SERVICE INSTRUCTION SI-09-06.1 Replaces SI-09-06 March—2013

SERVICE INSTRUCTION

Attention Installer/Customer: The mounting bolts (9946-xx) in the RCS pump kit (77844-xx) used to retain the RCS pump (Resin or Catalyst) onto the manifold have changed. Shown below is the process for installing the new bolts and required spacers.

Figure 1-1 "Incorrect Assembly Process"

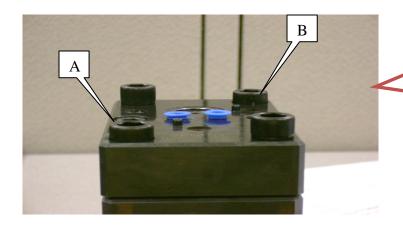
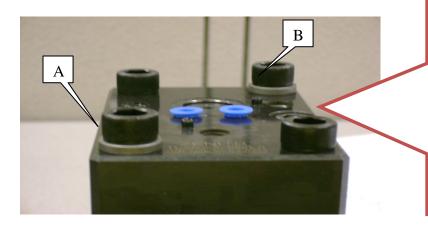
Figure 1-1 represents the "Incorrect" assembly process. Note that bolts "A" & "B" are sunk into the pump top plate, resting on the pump's dowel pins. This is incorrectly assembled. See figure 1-2 for correct installation of bolts "A" & "B".

Counter-sunk appearing ("A" & "B") bolts at diagonally opposite pump corners. There is no countersink in these locations, rather the bolts are resting on hollow locating pins (not visible here).

Figure 1-2 "Correct Assembly Process"

Stepped washers (A12304-00 Resin Pump; A12304-01 Catalyst pump) have been added to allow bolts at corners "A" & "B" to clamp down on pump corners instead of merely clamping down on the hollow locating pins at these locations.

Note: Use the longer bolts supplied in kit with the stepped washers. The smaller diameter of the stepped washer is inserted into the dowel hole.

CAUTION: Maximum torque specification for all four bolts is 44 ft-lb. Do not exceed torque specification or the washers may crack.
